Vermont Agency of Transportation
RECEIVED
Approach Slab Submittal 201126_Markup.pdf

| PRECAST CONCRETE APPROACH SLAB SHOP DRAWINGS (SDI JOB #15163) | | INSTALLER: CCS Construction, 138 Munson Ave, Morrisville, VT 05661, PH: 802-888-7701 | FABRICATOR: 193 INDUSTRIAL AVE. WILLISTON, VT 05495 Ph: (802) 658-0201 SD Ireland Precast Division |
| SUPERVISOR: M. WHEELER | PROJECT NAME: Stowe BRF 0235 (II) | | |
| ENGINEER: | | 11/20/14 | South Approach Slabs — 3 of 4 |

AS #1 Details

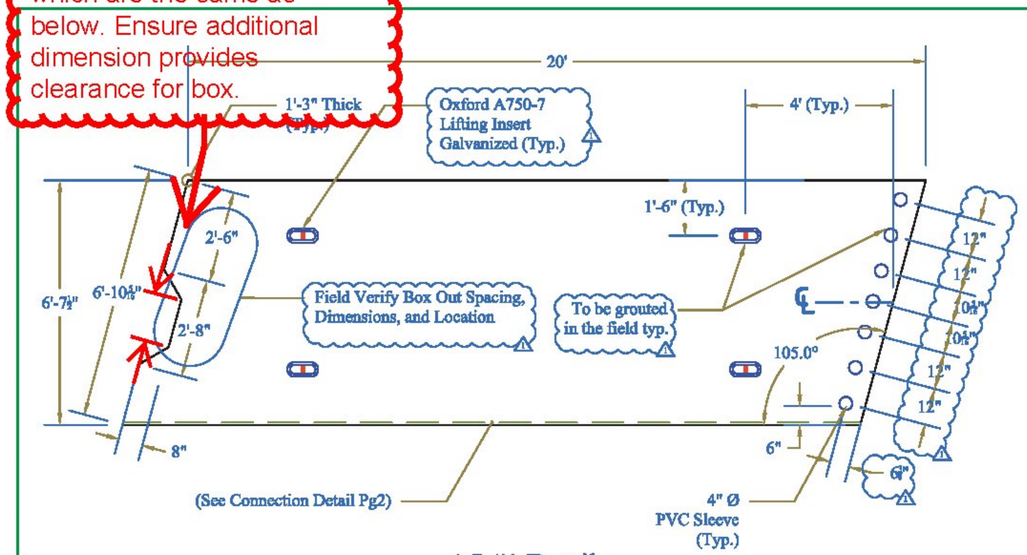
Per email, blockout dimensions will follow contract plan dimensions which are the same as below. Ensure additional dimension provides clearance for box.
